**DEPARTMENT OF TRANSPORTATION
STATE OF GEORGIA**

SUBJECT APPROVED REVISED CONCEPT REPORT

REVISED PROJECT CONCEPT REPORT

Project Number: CSSTP-0007-00 (414)

Reconstruction in Urban Section

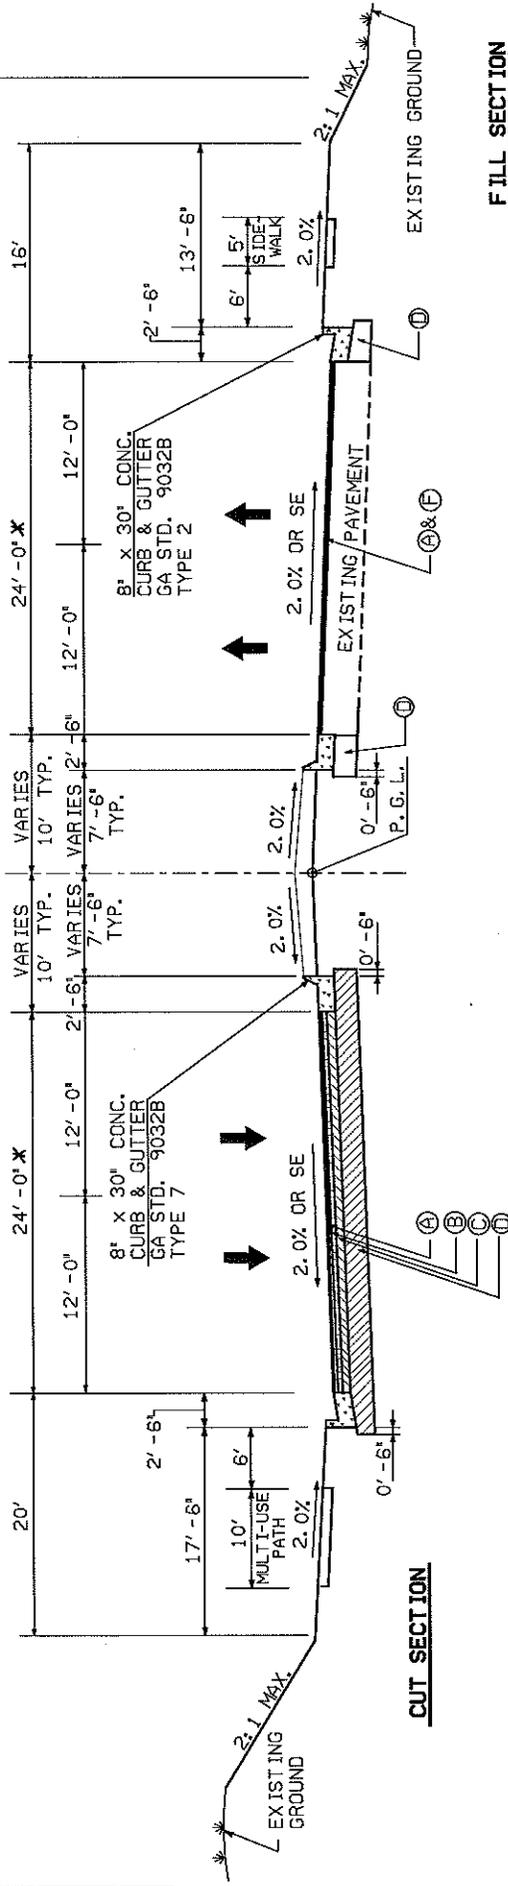
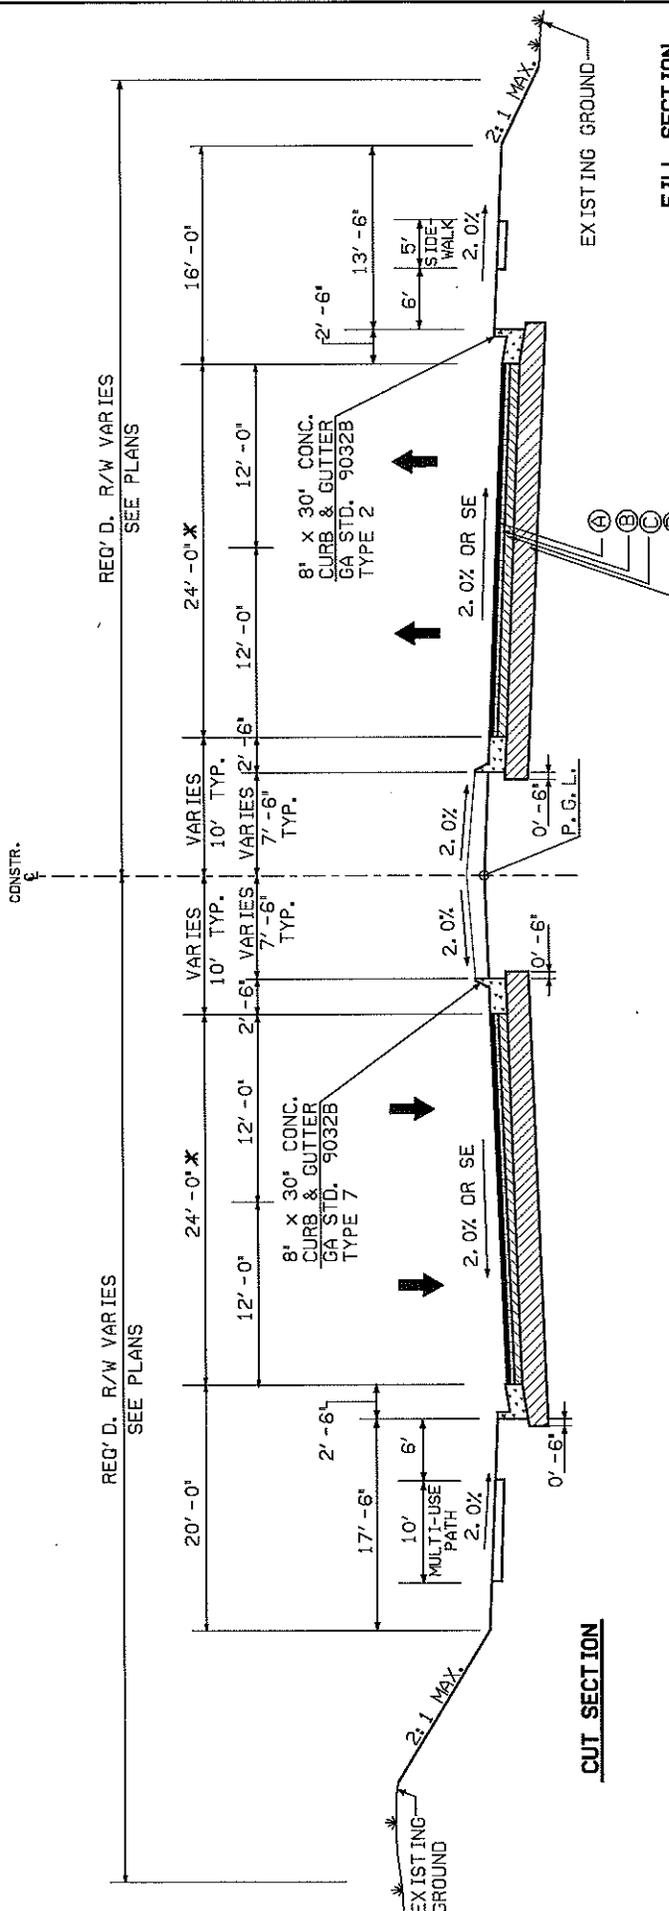
- The Colerain Road urban typical section from relocated Brazell Road to 3800 feet west of Winding Road consisting of 4-foot bike lanes and 5-foot sidewalks on both sides is changed to a 10-foot multi-use path on the north side and a 5-foot sidewalk on the south side, see Attachment No. 2. This would result in an estimated savings of \$220,679 in construction while meeting the bike lane requirements on Colerain Road, which is shown as being on the Camden County bike route system. The multi-use path scenario also encompasses comment number one in GDOT's April 20, 2009 Public Information Open House response letter, see Attachment No 5. The proposed urban typical is extended from 3,800 feet west of Winding Road to Winding Road. The additional 3,800 feet of an urban versus rural typical section would provide sidewalks to the nearby county high school, which would be used by the substantial residential development planned for this area. The use of an urban shoulder would also minimize impacts to the tree canopy on the south side of Colerain Road approximately 1,090 feet to 470 west of Winding Road by eliminating the roadside ditch.

- Implementation of Value Engineering Study alternative DR-3 dated September 29, 2009, see Attachments No. 2 & 6, changed the proposed urban shoulders in fill to slope to drain away from the proposed roadway. This would preserve the existing sheet flow conditions while reducing the flow at the proposed storm drain outfalls.

Reconstruction in Rural Section

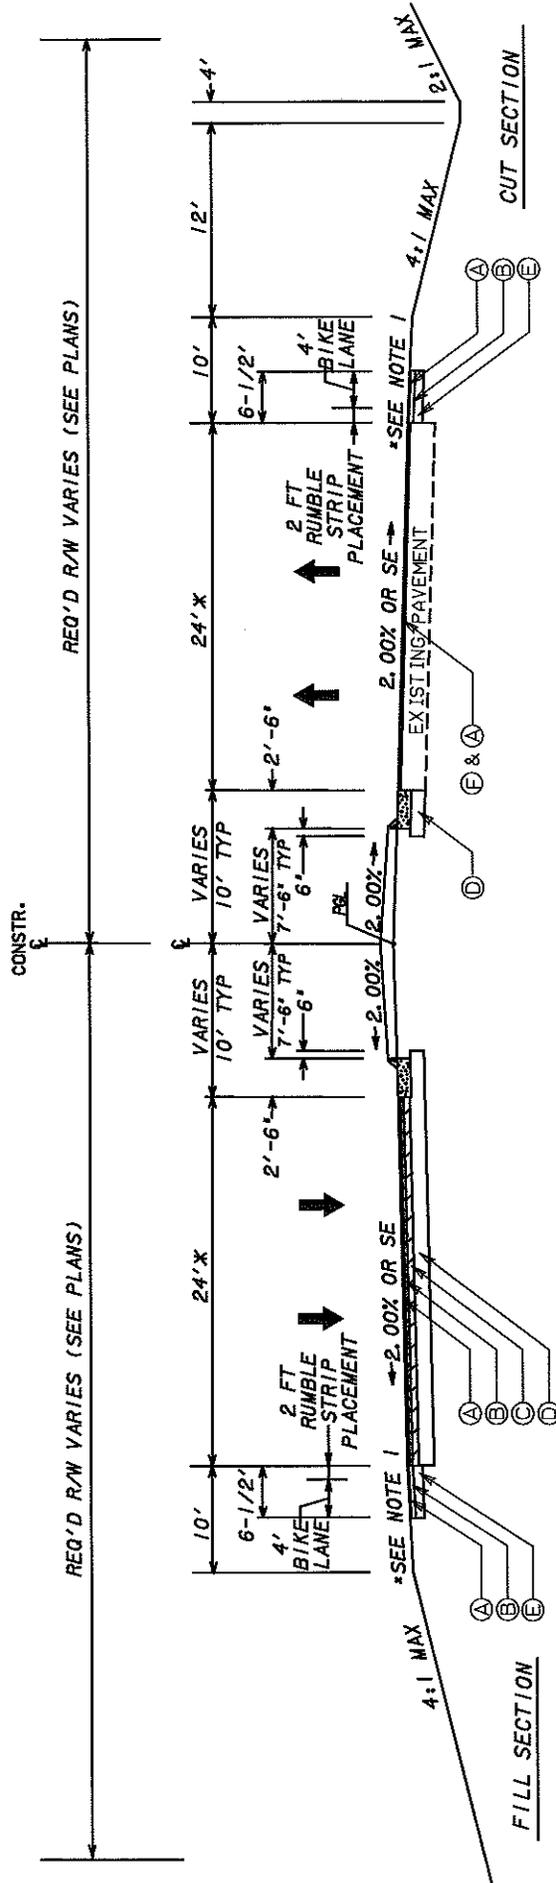
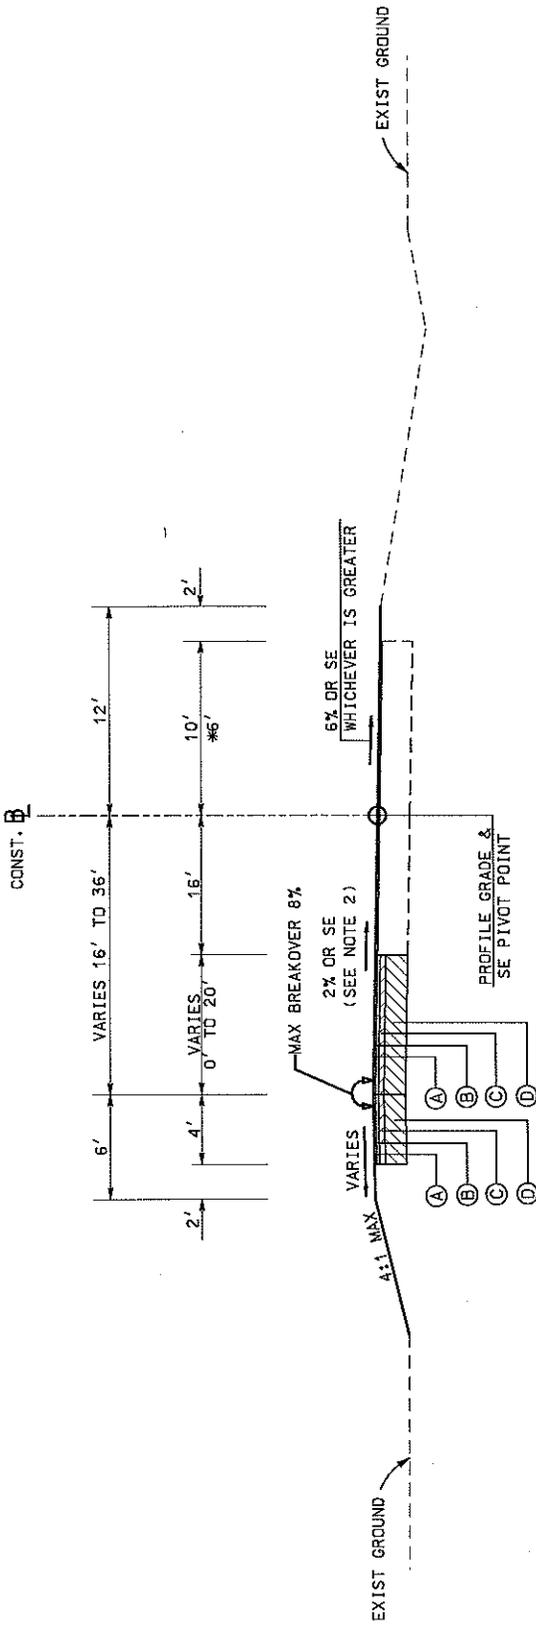
- Implementation of Value Engineering Study alternative RD-2 dated September 29, 2009 changed the rural typical section from 4-foot bike lanes and 10-foot shoulders (6'-6" paved and 3'-6" grass) to 10-foot shoulders consisting of 4-foot paved bike lanes and 6-foot grass in each direction. The January 23, 2012 Value Engineering Implementation Revision Request for alternative RD-2 would change the rural typical section from 10-foot shoulders consisting of 4-foot paved bike lanes and 6-foot grass to 10-foot shoulders consisting of 3-foot, 6-inch grass shoulders and 6-foot, 6-inch paved shoulders including 4-foot bike lanes and 16-inch rumble strips in each direction. The revised typical shoulder section would meet GDOT Design Policy Manual Section 9.5.2 Bicycle Facility Design 1. On-street Bicycle Facility page 9-11 revised March 1, 2011. The VE Reversal of Recommendation RD-2 to reduce the paved shoulder width from 6-foot, 6-inches to 4-foot would negate the estimated \$126,328 savings outlined in the Value Engineering Study Report. However an estimated savings of \$258,716 not outlined in the VE Study Report would result by including the 4-foot bike lane as apart of rather than in addition to the 6-foot, 6-inch paved shoulder as shown in the approved concept report. The raised median is changed from 24-foot to 20-foot to reduce the proposed roadway footprint and match the approved urban typical section. See Attachments No 2 & 6.

Review of the revised concept report determined that the proposed 10-foot rural outside shoulder consisting of 4-foot paved and 6-foot grass did not meet the requirements of a 6-foot, 6-inch paved shoulder for a 4-foot bike lane including a 16-inch rumble strip offset 12-inches from the travel way per GDOT Design Policy Manual, Section 9.5.2 Bicycle facility Design 1. On-street Bicycle Facility page 9-11 revised March 1, 2011.

It appears there has been some misinterpretation of policy 6.5.1. Rumble Strips, relevant to bicycle accommodations. When a "bike lane" (painted stripe and symbol) is planned for a multi-lane roadway such as this, the 6.5-ft paved shoulder with rumble strip should be provided. If this was not on a planned bike route, then the 4-ft paved shoulder without rumble strip would be an appropriate option. It's my understanding that this particular project is on the local governments bicycle plan network and has therefore been designated as a bicycle route with "On-Street Bicycle Facility", painted stripe and symbols. (see GDOT DPM 9.5.2 and Figure 9.4). It is also my understanding that the overall graded shoulder width of 10-ft will not change. We did our own calculations and we estimate the cost difference between 4-ft paved and 6.5-ft paved to be \$65,000 for this one mile section. Therefore, we recommend the 6.5-ft paved shoulder with rumble strip. The striped bike lane should terminate at an intersection with cross walk to the multi-use path. Keith Posey will hold the CR until this is settled. Let me know if you want to talk further.

Dana, Brent and I need some help figuring this out.....It appears that the CR revision was primarily for the VE study changes and one of the VE Study implementation items was to change the rural shoulder from Winding Rd. to 1496 feet east of Kings Bay Rd. The rural shoulder was to remain rural, however, the 10' shoulder was proposed to change from 6' 6" paved and 3' 6" graded to 4' paved and 6' graded. The 4' paved was intended to

be used as a bike lane, however, it's now being questioned. It is GDOT policy that if we use a shoulder/shared bike lane, the shoulder must be 6.5' to give you the 4' clear area because of the rumble strips.

It appears that we will have to change the typical to show the 6.5' paved shoulder thru this section. Once we have done so, the RCR will be approved.

I am going to venture to say that everything is ok, we just need to change the typical and not use this one VE Study implementation item. The roadway through this section will remain rural (as agreed upon in the Oct 6th meeting with FHWA Jennifer Giersch for DEA doc) and we will just need to change the paved shoulder width back to 6.5' to stay within policy.

LAUREL ISLAND PKWY (COLERAIN ROAD) ACCESS PLAN

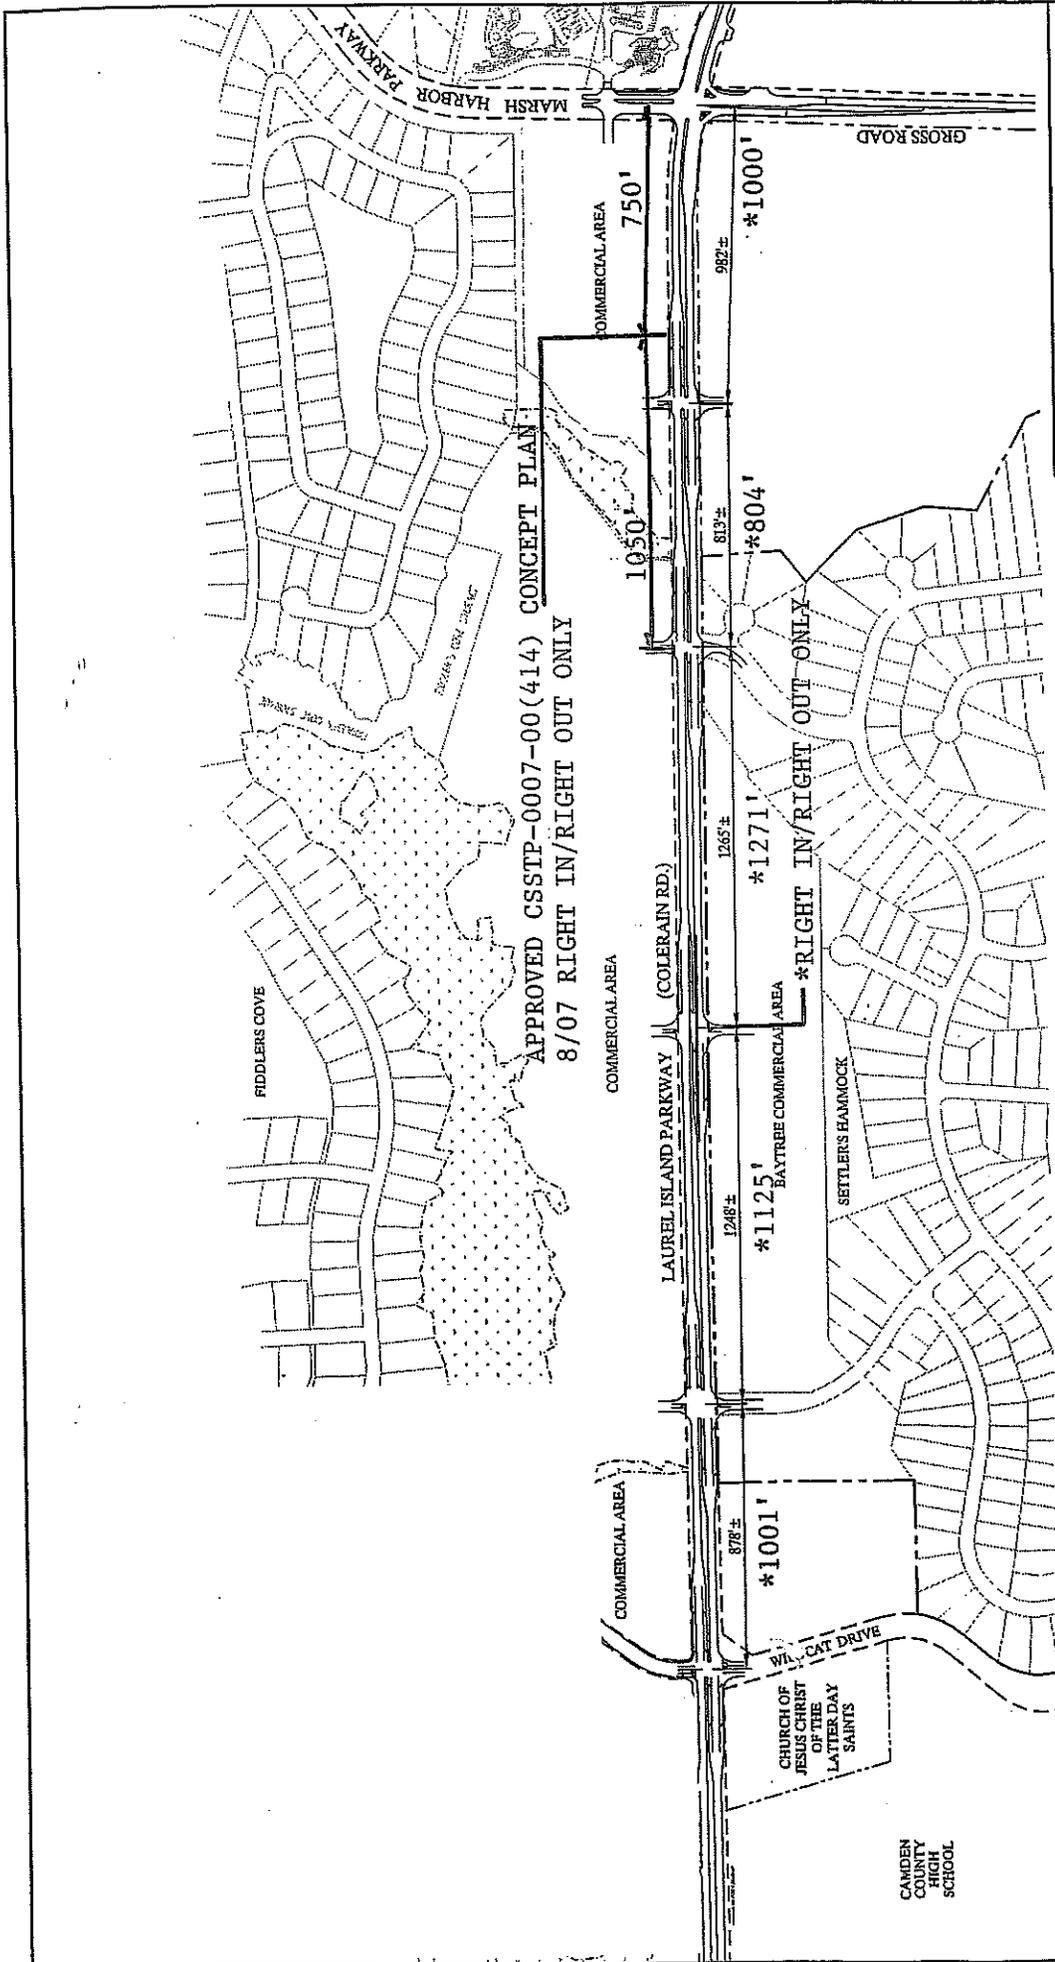
- The approved concept plan showed a proposed right in/ right out driveway on the left (north) side of Colerain Road approximately 1050 feet east of the proposed median opening at the existing subdivision road and 750 feet west of the proposed median opening at North Gross Road/ Marsh Harbour Parkway. GDOT District Five provided a Colerain Road Access Plan by P & A Engineering dated 5/05/09 on behalf of the City of Kingland's request for a median opening to serve driveways on the left (north) and right (south) sides of Colerain Road approximately 804 feet east of the proposed median opening at the existing subdivision road and 1000 feet west of the proposed median opening at North Gross Road/ Marsh Harbour Parkway. See Attachment No. 8. This median opening would provide access to the future development in the northwest and southwest quadrants of the Colerain Road/North Gross Road/ Marsh Harbour Parkway intersection and eliminate westbound and eastbound u-turn movements at the Colerain Road/Subdivision Road and Colerain Road/North Gross Road/Marsh Harbour Parkway intersections respectively. A Design Variance for GDOT Design Policy Manual- Version 2.0 Section 7.3 Median Openings may be required for the proposed 804-foot versus the required 1000-foot (660-foot minimum for minimal left turn volumes) median opening spacing on Colerain Road.

* PROJECT CSSTP-0007-00 (414) ACTUAL DIMENSIONS PER CONSTRUCTION PLANS BY MORELAND ALTOBELLI ASSOCIATES INCORPORATE THE REQUESTED MEDIAN OPENINGS BUT WILL NOT CONSTRUCT DRIVEWAYS THAT ARE NOT ALREADY THERE.
